**SOLICITATION AMENDMENT**  
**MODIFICATION DE L'INVITATION**

<b>Title - Sujet</b> Lansdowne Server replacement(CCTV)	
<b>Solicitation No. - N° de l'invitation</b> 47419-153363/A	<b>Amendment No. - N° modif.</b> 001
<b>Client Reference No. - N° de référence du client</b> 1000323363	<b>Date</b> 2015-02-27
<b>GETS Reference No. - N° de référence de SEAG</b> PW-\$\$HN-461-66749	
<b>File No. - N° de dossier</b> hn461.47419-153363	<b>CCC No./N° CCC - FMS No./N° VME</b>
<b>Solicitation Closes - L'invitation prend fin</b> <b>at - à 02:00 PM</b> <b>on - le 2015-03-13</b>	
<b>F.O.B. - F.A.B.</b> <b>Plant-Usine:</b> <input type="checkbox"/> <b>Destination:</b> <input type="checkbox"/> <b>Other-Autre:</b> <input type="checkbox"/>	
<b>Address Enquiries to: - Adresser toutes questions à:</b> Hallman, Patti	<b>Buyer Id - Id de l'acheteur</b> hn461
<b>Telephone No. - N° de téléphone</b> (819) 956-7390 ( )	<b>FAX No. - N° de FAX</b> ( ) -
<b>Destination - of Goods, Services, and Construction:</b> <b>Destination - des biens, services et construction:</b>

*Amendment 001 is issued to amend the solicitation close date and provide responses to the Questions received, to update Annex A and Attachment

### Traffic Building

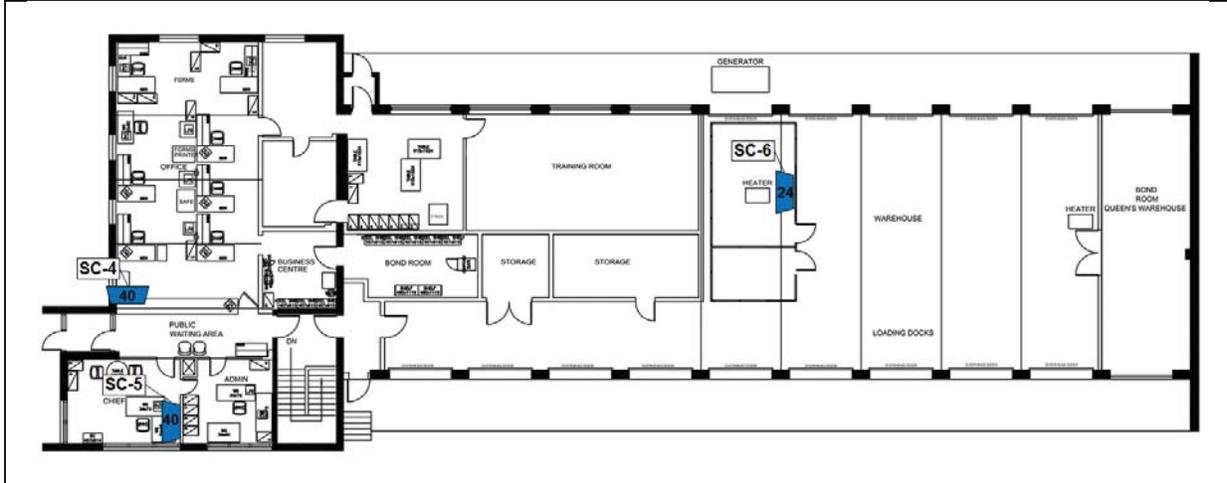
*Amendment on size – Due to lack of space, the SC-2 monitor size is reduced from 40 inch to 32 inch.*

Identifier	Location	Monitor	Notes
SC-1	Immigration Office	Provided by CBSA	On desk
SC-2	Customer Service Desk	32	Mount that permits tilt, extend and swivel
SC-3	Superintendent Office	Provided by CBSA	On desk. Dual-display with existing monitor.

## Section 3 - Repair/Replacement Layout

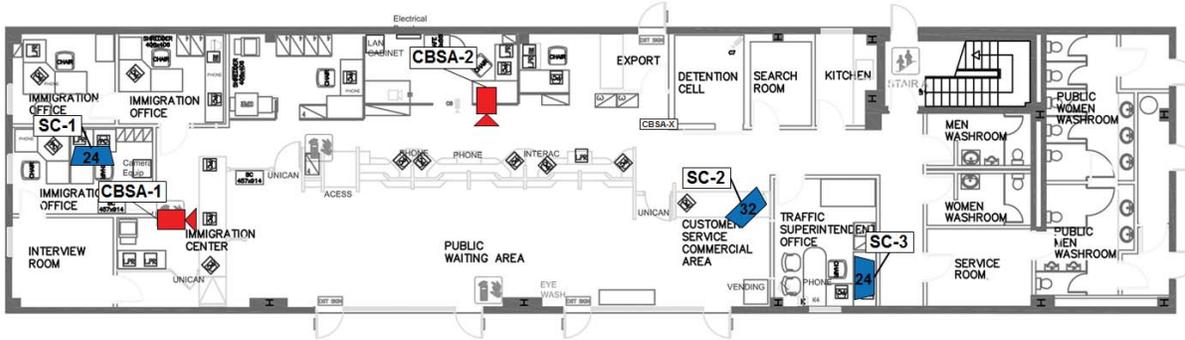
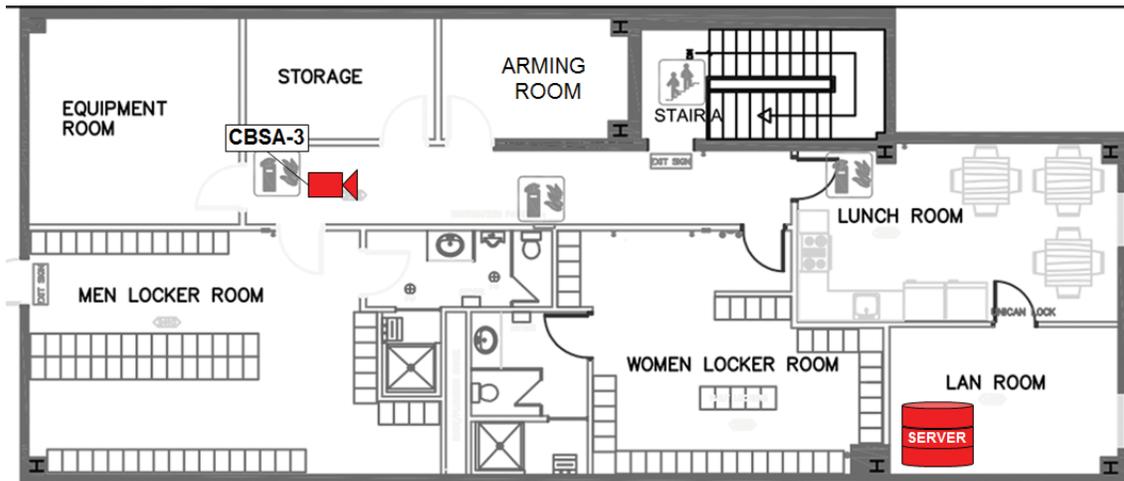
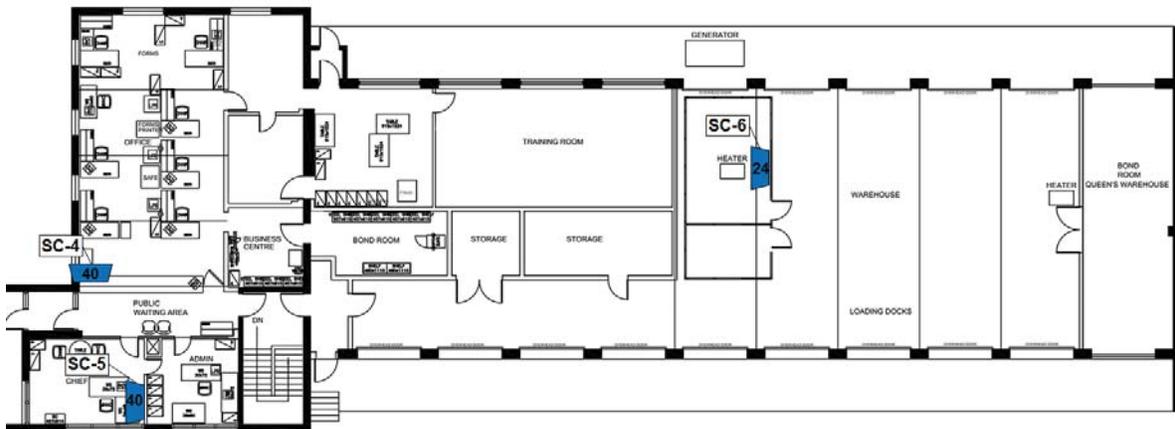
- *Status Change: Camera 1 is a replacement camera and not a new camera.*
- *Status Change: Camera 4 is a new camera and not being replaced as previously indicated.*
- *Type Change: Camera 5 is now a PTZ.*
- *Location Change: Camera 8 located on corner of traffic building and not on corner of the secondary canopy. See drawing in Section 3 – Repair/Replacement Layout, Site.*
- *New replacement: Camera 5 and 6 in Table 5 – Existing Camera List.*
- *Table change: Camera 9 and 10 to be replaced according to Table 9 – General Outdoor Camera.*

Camera #	Location	Type	Table	Status	Mount Type
1	Traffic – Immigration Counter	FIX	8	Replace existing	Recessed
2	Traffic – Public Counter	FIX	8	New	Recessed
3	Traffic – Floor 2 – Hallway	FIX	8	New	Recessed
4	Exterior – North West Corner	PTZ	7	New	Corner mount
5	Exterior – Public Entry	PTZ	7	Replace existing	Wall mount
6	Exterior – PIL View	FIX	8	New	Wall mount
7	Exterior – Secondary View	PTZ	7	Replace existing	Wall mount
8	Exterior – South West Corner of Traffic Building	PTZ	7	New	Corner mount
9	Exterior – Post PIL	FIX	9	Replace existing	Pole mount
10	Exterior – Pre PIL	FIX	9	Replace existing	Pole mount
11	PIL 3-2	FIX	8	Replace existing	Pole mount
12	PIL 4	FIX	8	Replace existing	Pole mount

Camera numbers from this Table are in relation to Section 3 – Repair/Replacement Layout.
